**BLUE BIRD**

**R11TA**

**SUBJECT: RECALL R11TA STARTER CABLE MAY CONTACT POWER  
STEERING HOSE**

## Starter Cable May Contact Power Steering Hose

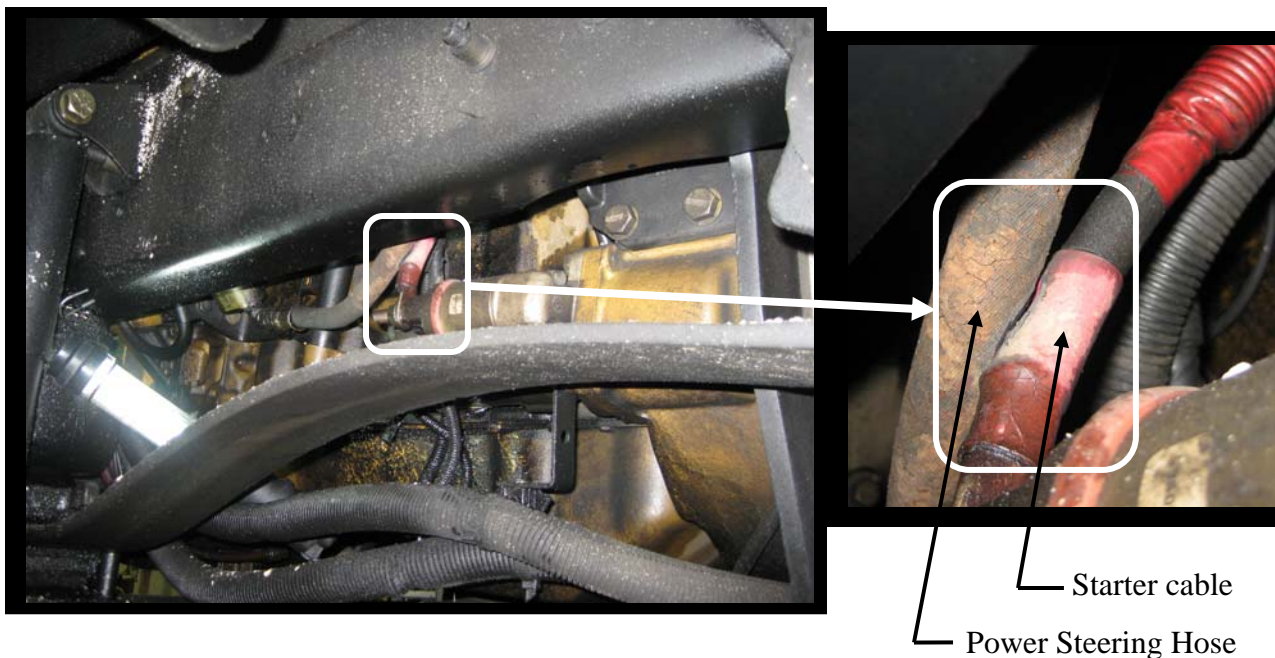
The starter cable may contact and potentially chafe against the steel braided power steering hose thereby creating a direct short which could result in a fire.

1. Park the bus on a level surface, apply parking brake, and remove ignition key and chock wheels.
2. Disconnect Batteries: Note when disconnecting the batteries, remove the Negative cable first.
3. On lower left side (driver's) of engine; inspect the positive starter cable and power steering hose for possible contact as shown below.

Inspect for proper clearance between the starter cable and the power steering hose. If insufficient clearance is found, install a clamp to prevent further contact. Any damaged power steering hoses or starter cables must be replaced.

Install dual swivel saddle mount and cable ties.

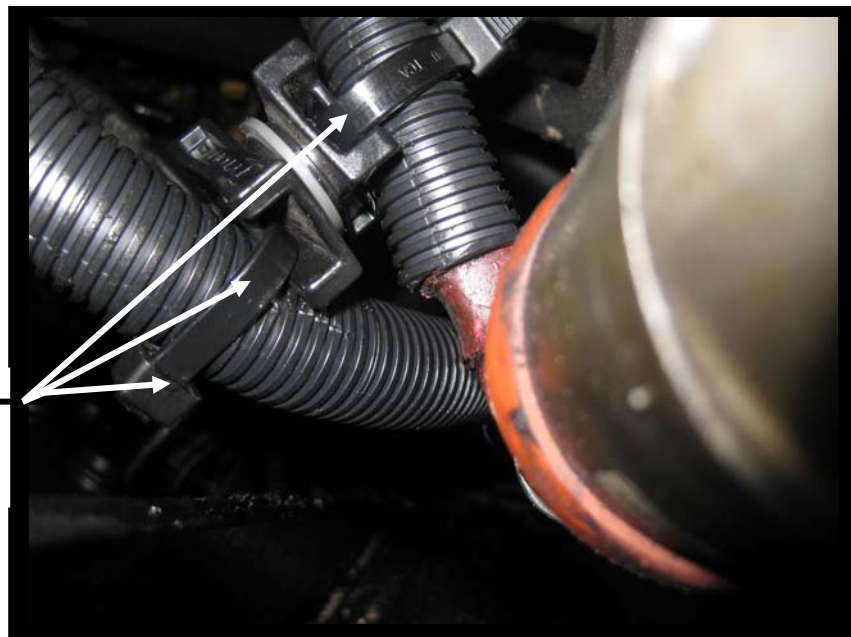
- 4. If the starter cable has contacted the power steering hose, separate and inspect both for any possible damage. If either has been damaged, contact Blue Bird Recall Administrator for a replacement.
- 5. If there is no contact and a minimum of one (1) inch clearance between the starter cable and power steering hose, no further action is required.
- 6. If there less than one (1) inch clearance, install a dual swivel saddle mount and two cables ties between the power steering hose and starter cable and secure with two cable ties.
